AGENDA

Planning Board

b. MAPP-01-24 Major Subdivision Preliminary Plat Application for Hyland Hills Townhomes

c. MAPP-02-24 Major Subdivision Preliminary Plat Application for Clark Street Townhomes

Figure 4: HCO Buffer Purpose and Context - Compared with Existing Adjacent Townhomes

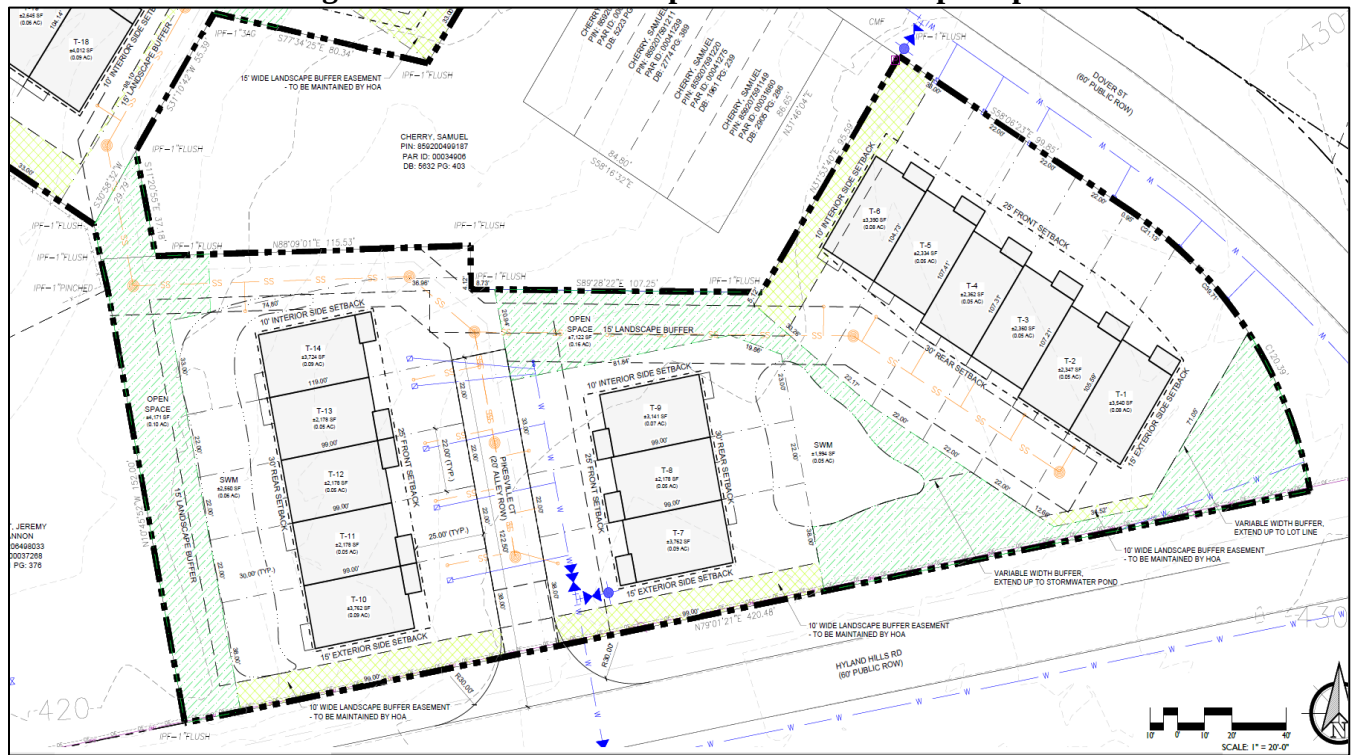
Since this development is a townhome development, the more restrictive requirements under exhibit 3-13 do not apply. However, the underlying requirements in UDO Chapter 4, which include cross-references to HCO planting buffers in §4.3.4, are still present and apply. **Figure 4** helps illustrate the purpose and positive effects of retaining highway yard buffers; retaining the natural character of the town and providing a noise and sightline buffer for future townhome residents are most important.

The applicant requests a variation to reduce and vary the 50' highway yard buffer to widths of approximately 10'-40', maximizing everywhere possible. Where this buffer must intersect with individual townhome lots due to building setback constraints, the applicant has stated a landscaping deed of easement shall be included to ensure lot owners do not remove the buffer. The easement will direct buffer maintenance control to the Hyland Hills homeowners' association. **Figure 5** demonstrates what this buffer layout will look like (reference Attachment 3 for the full preliminary plat site map).
